High School in Jerrabomberra

Response to Submissions and SDRP

30.03.2022

BUILDING VOLUME RATIONALE | OPPORTUNITIES FOR NATURAL VENTILATION

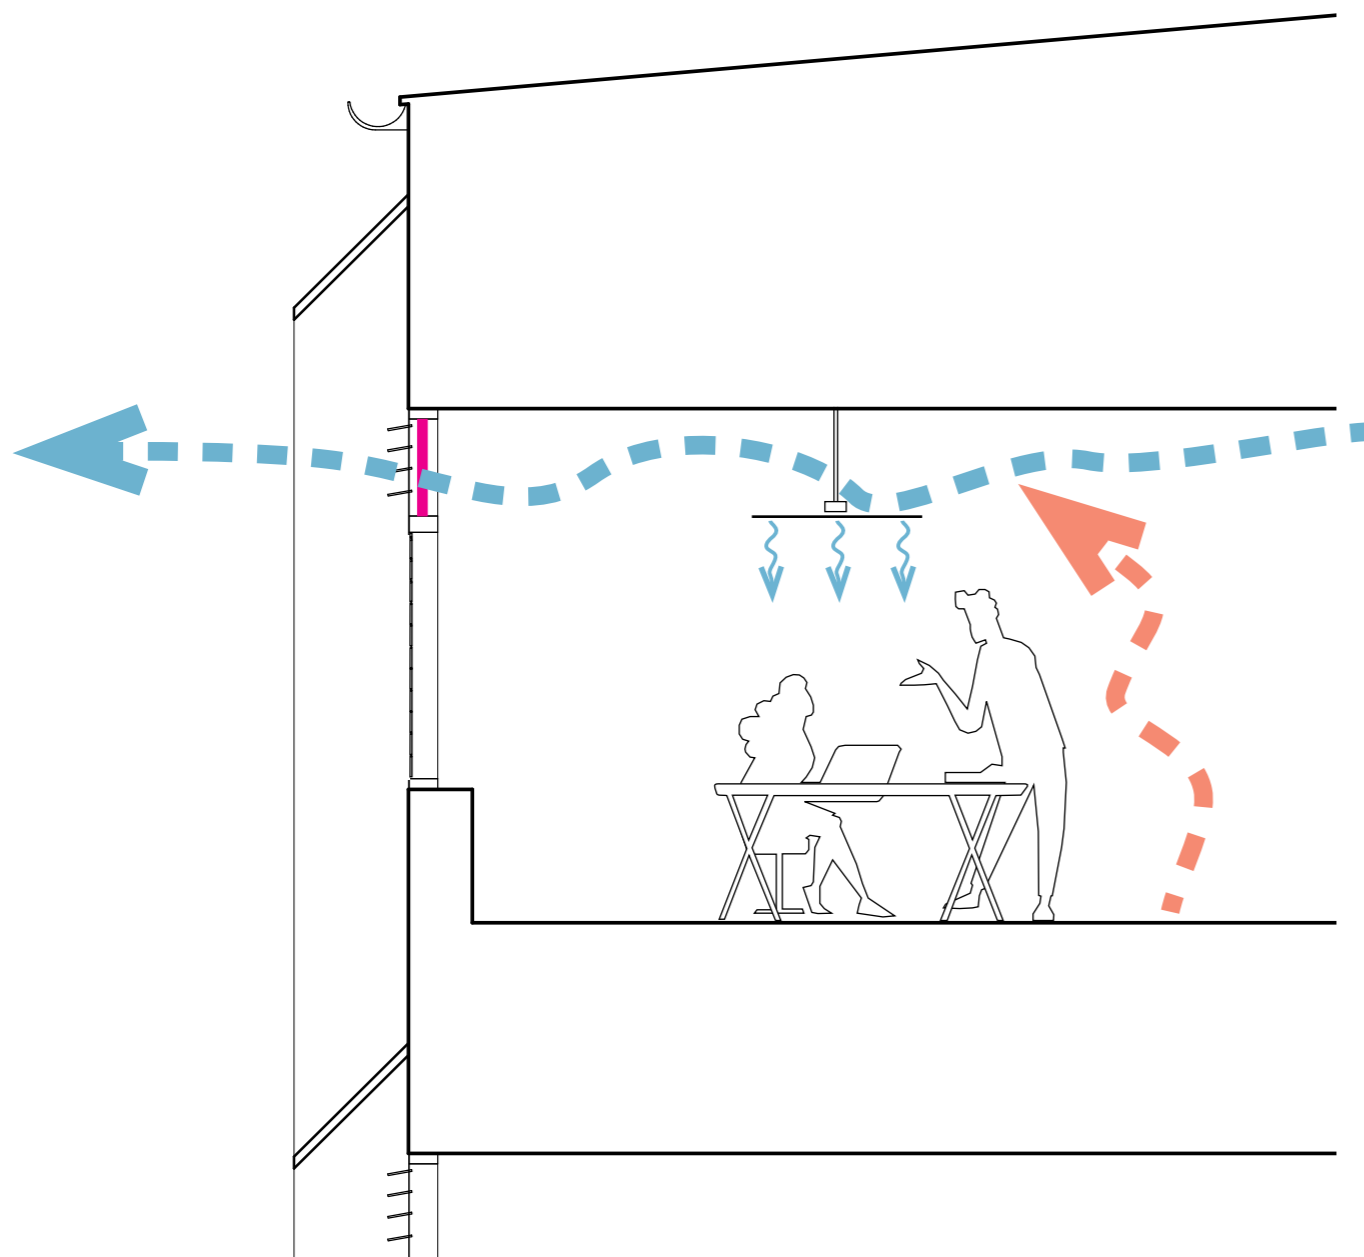
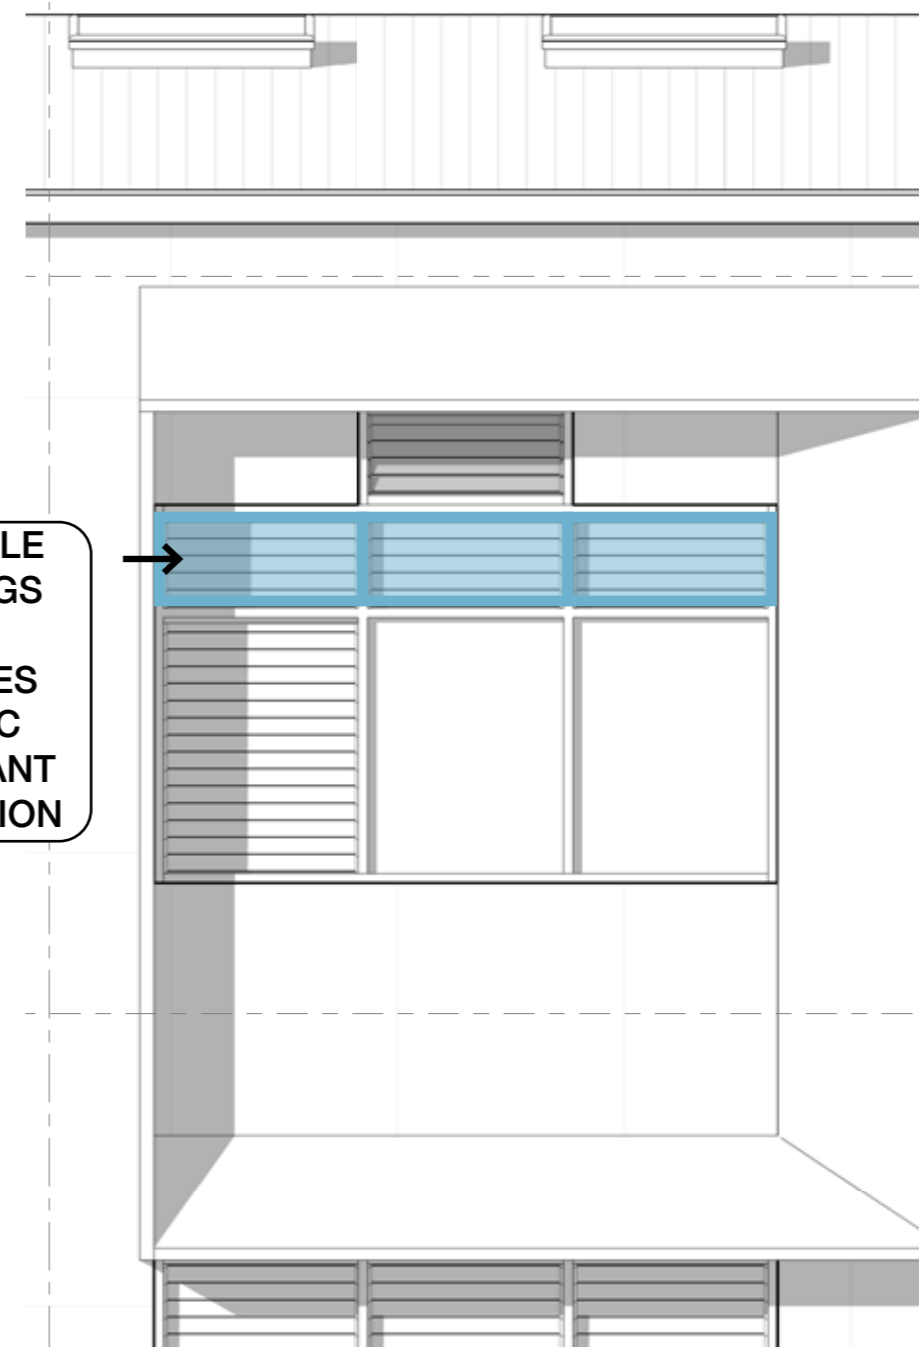
Recommendations 11 and 12a – opportunities must be pursued to articulate the volume of Building A along Environa Drive to reduce the visual bulk and allow for more opportunities for natural ventilation.

- Users can operate louvre banks for high level cross ventilation.
- Fans assist with the cooling effect

OPERABLE
OPENINGS
ACHIEVES
5% NCC
COMPLIANT
VENTILATION

BUILDING VOLUME RATIONALE | OPPORTUNITIES FOR NATURAL VENTILATION

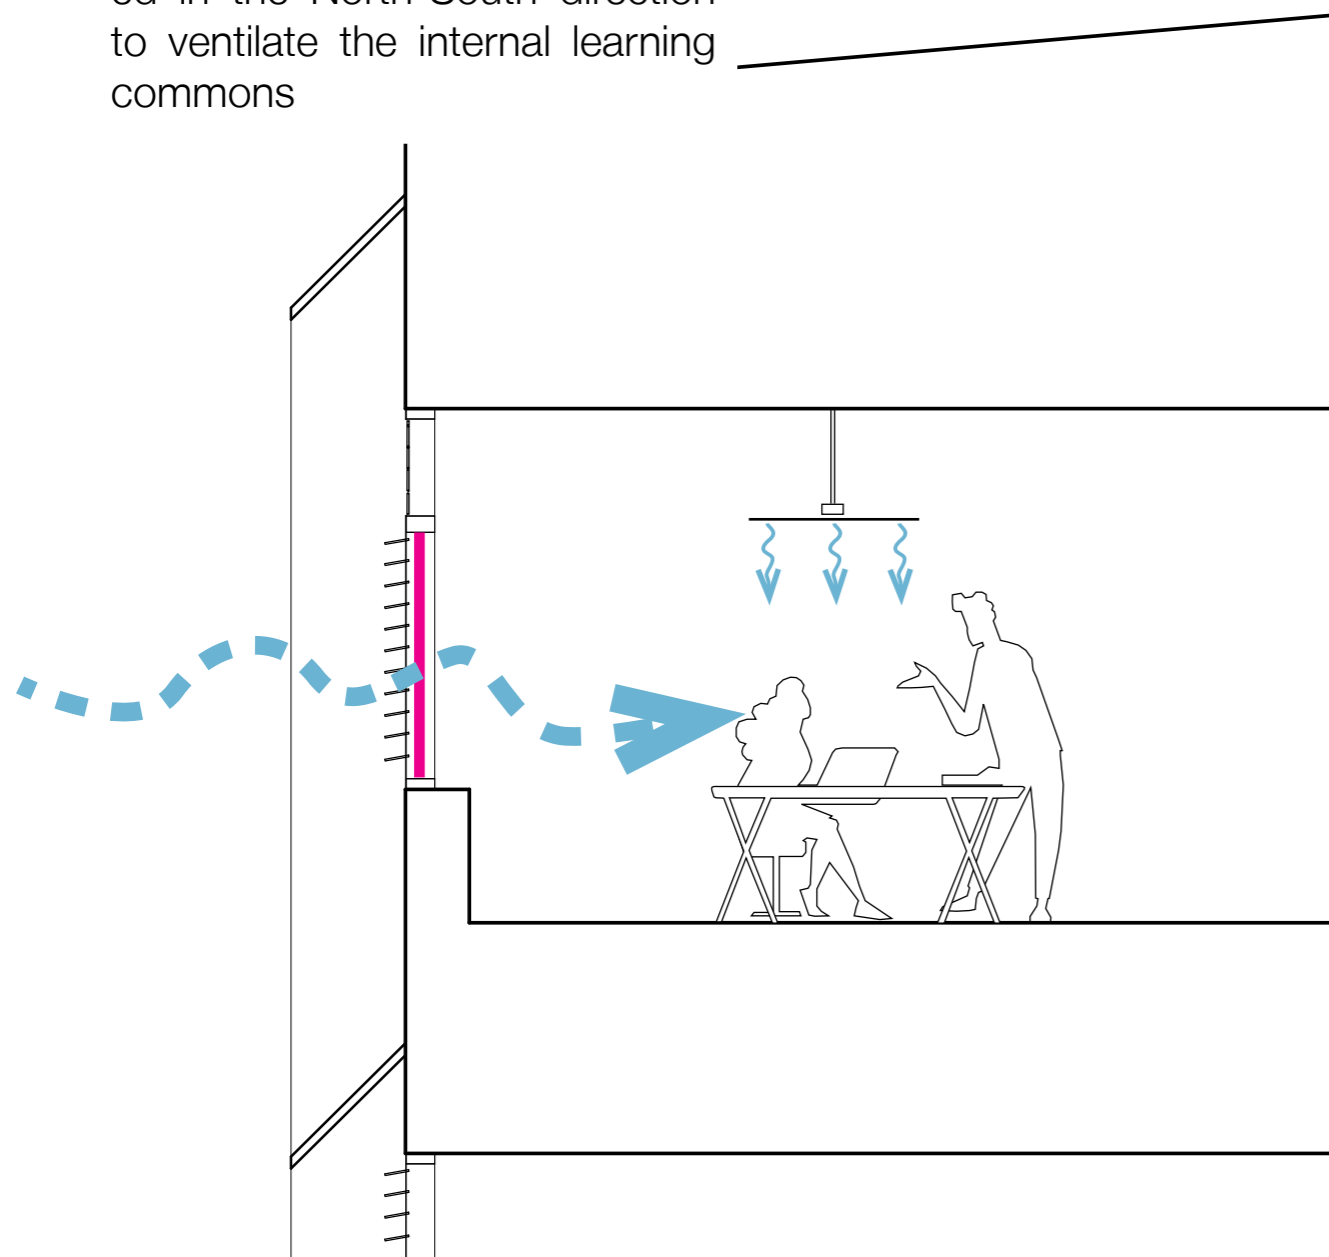
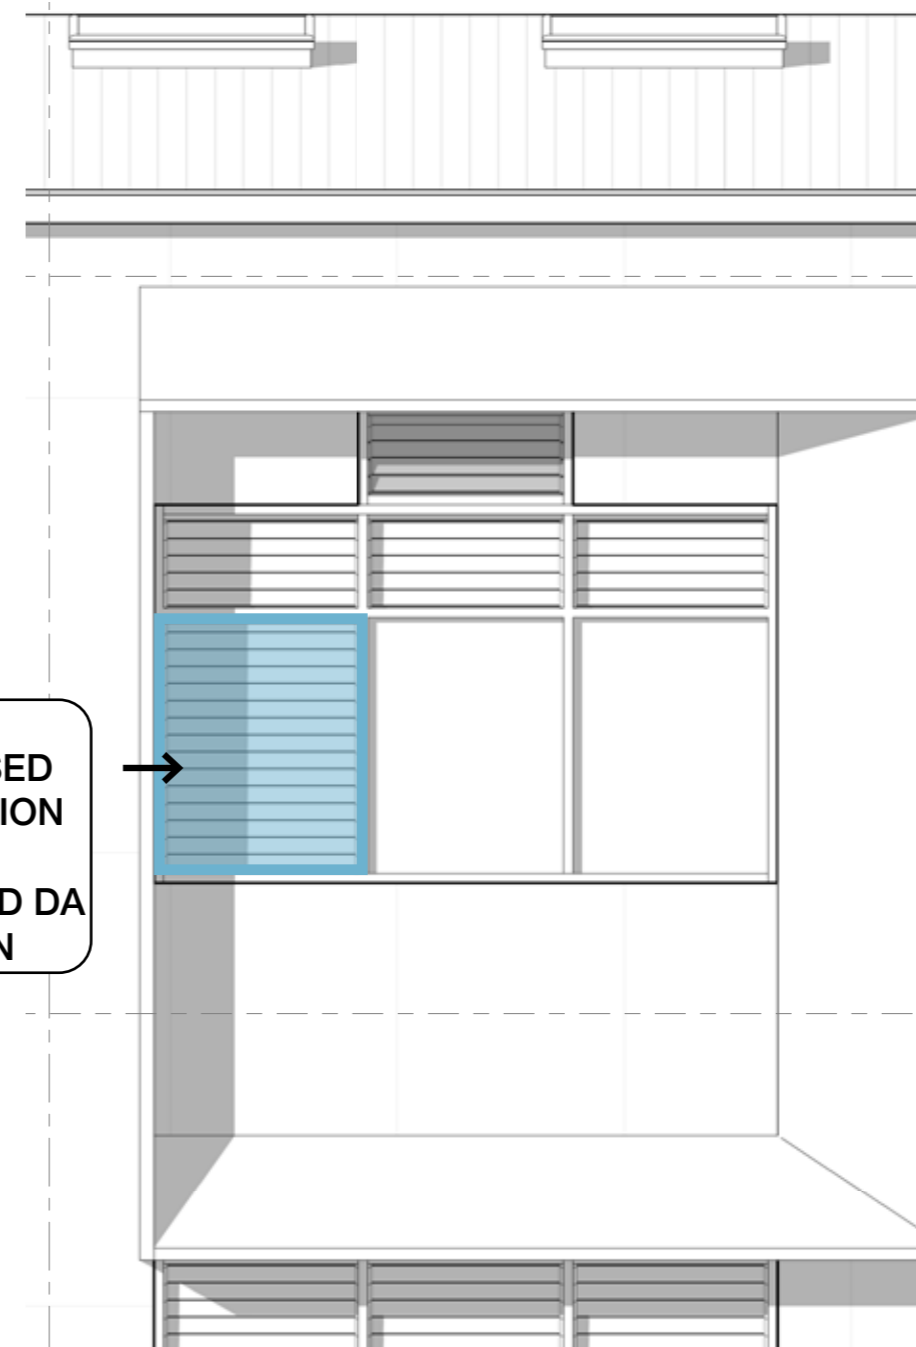
Recommendations 11 and 12a – opportunities must be pursued to articulate the volume of Building A along Environa Drive to reduce the visual bulk and allow for more opportunities for natural ventilation.

- Lower level louvre banks provide air movement at occupant level.
- These louvres are additional to the previously submitted DA design
- Additional louvre banks to original DA design have also been added in the North-South direction to ventilate the internal learning commons

43%
INCREASED
VENTILATION
FROM
SUBMITTED DA
DESIGN

SOUTH WEST VIEW

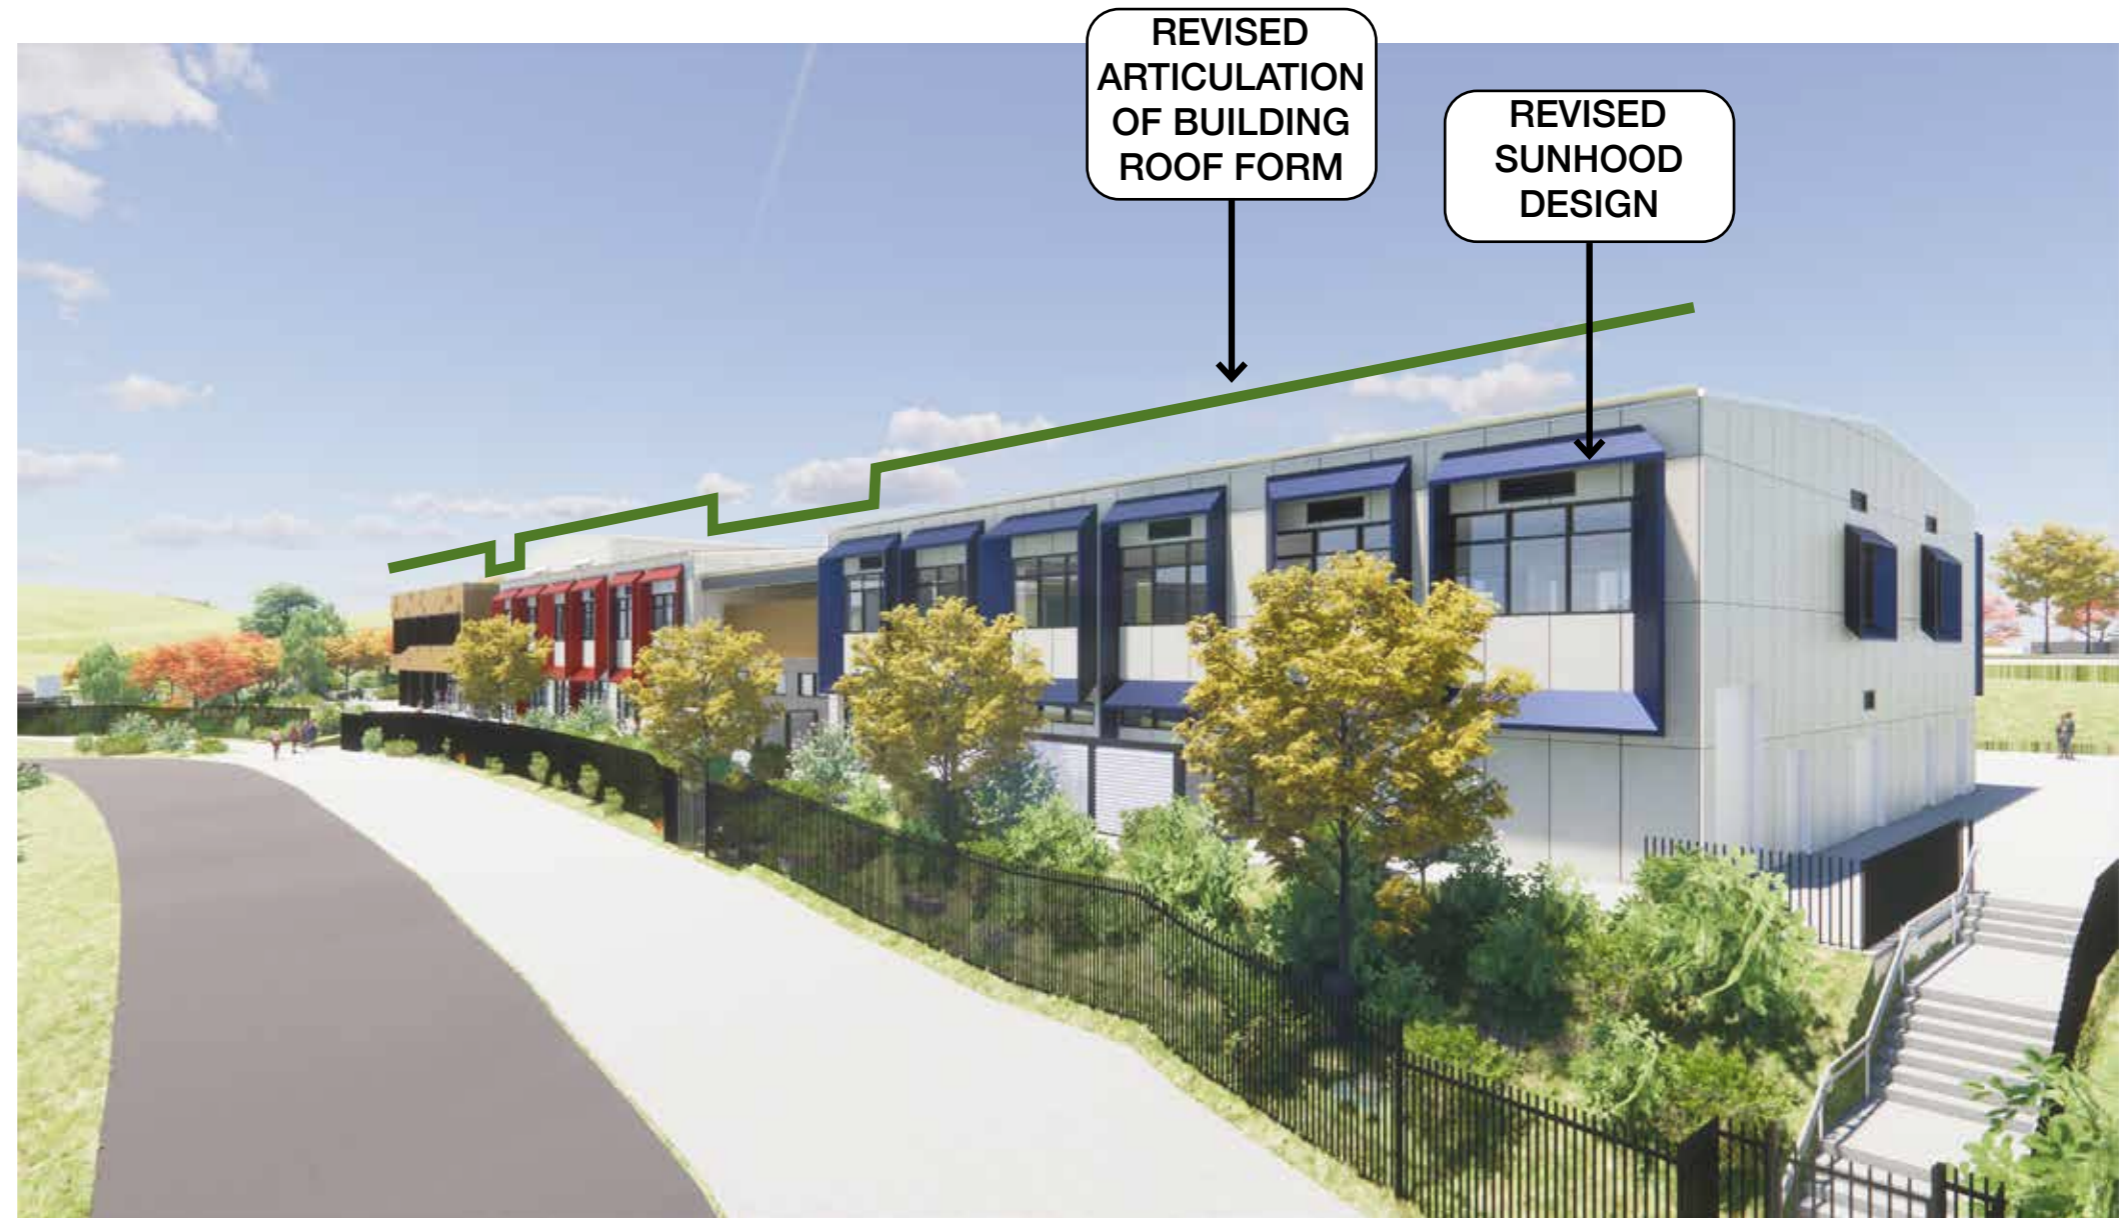
Recommendations 11 and 12a – opportunities must be pursued to articulate the volume of Building A along Environa Drive to reduce the visual bulk and allow for more opportunities for natural ventilation.

- The revised design has enhanced articulation.
- Articulation of the building form to allow porosity for natural ventilation and reduction of the visual bulk and scale.
- The roof has been modified from the DA design to provide greater expression of the separation of the building volume.
- The revised sunhood design provides greater variety and articulation of the building volume.

NORTH WEST VIEW

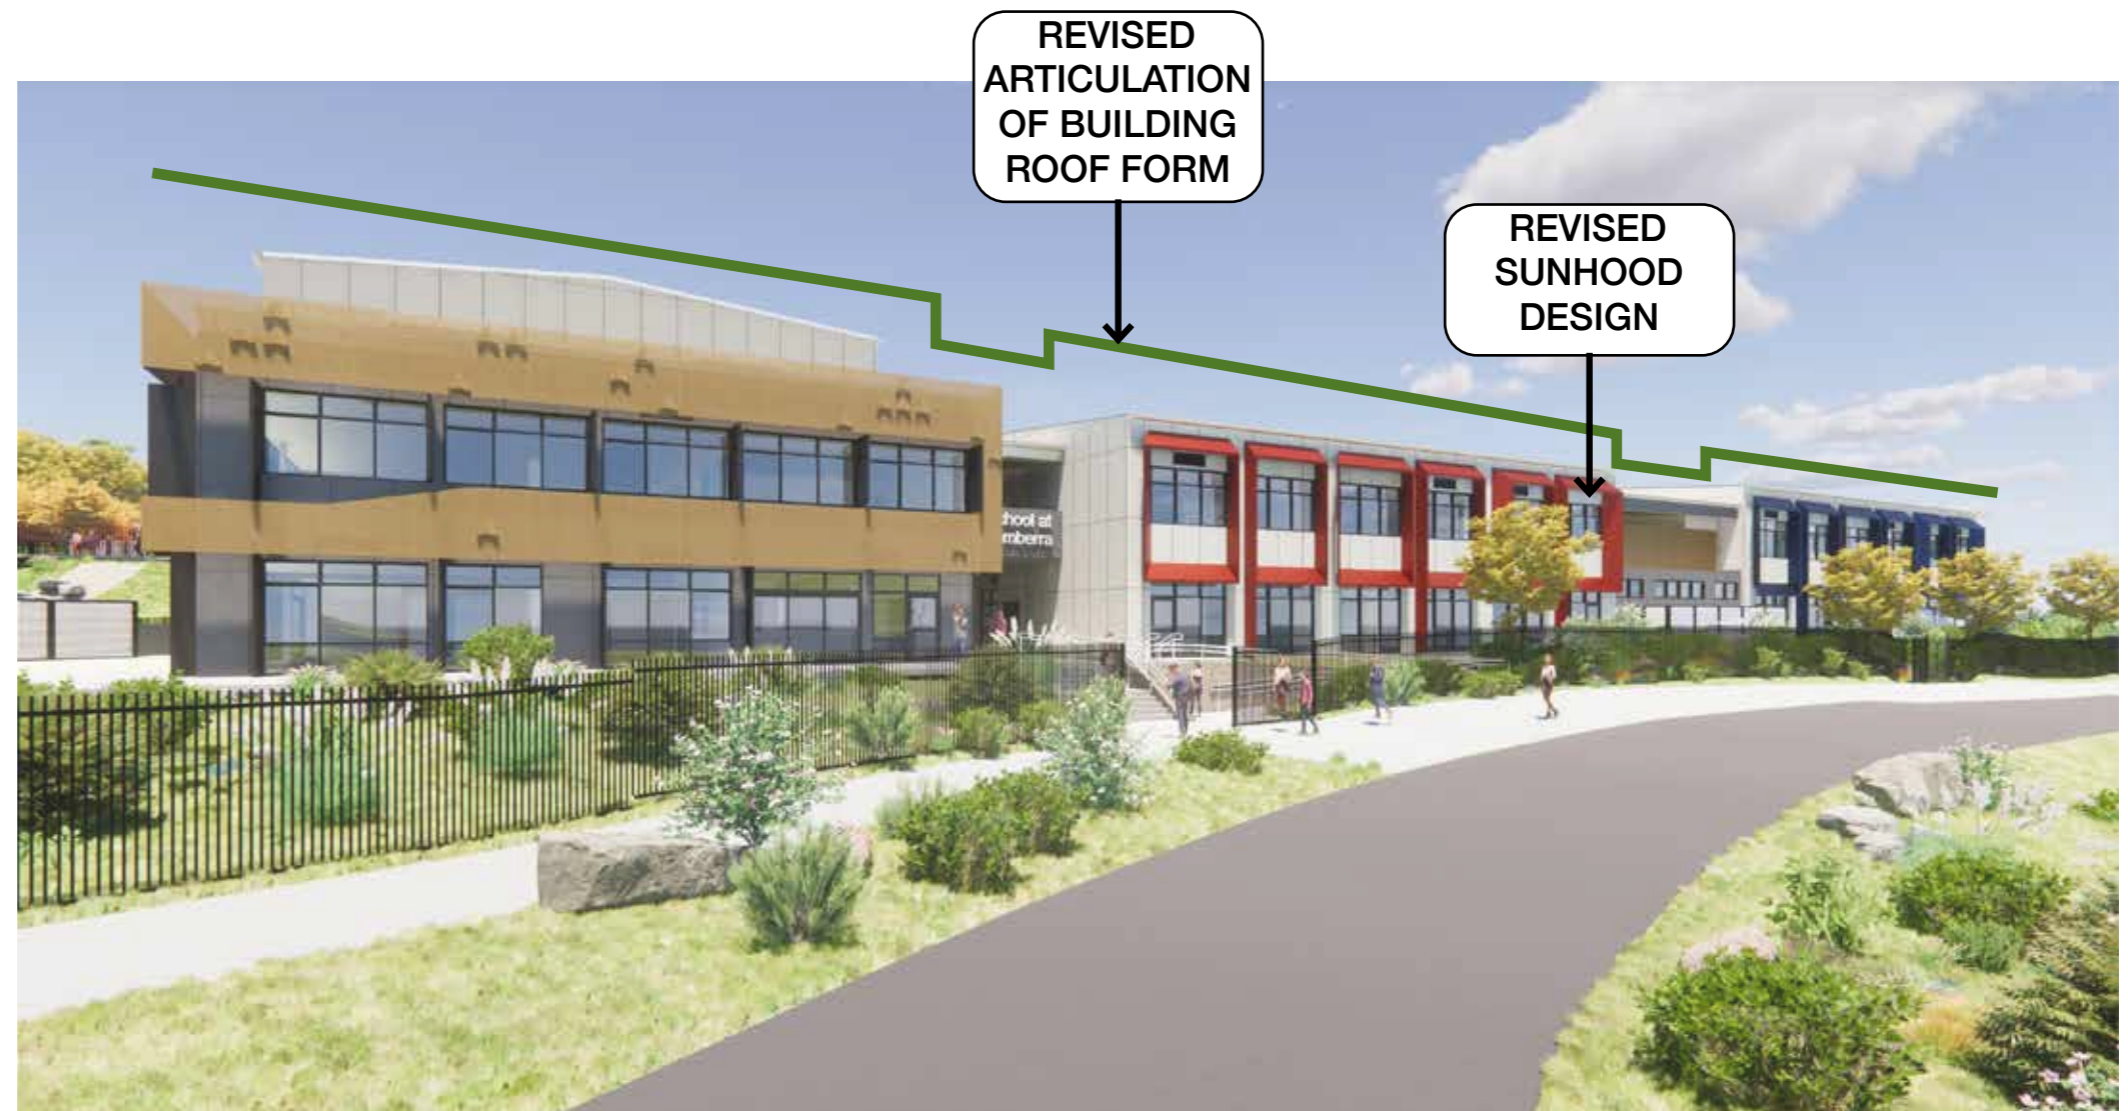
Recommendations 11 and 12a – opportunities must be pursued to articulate the volume of Building A along Environa Drive to reduce the visual bulk and allow for more opportunities for natural ventilation.

- The revised design has enhanced articulation.
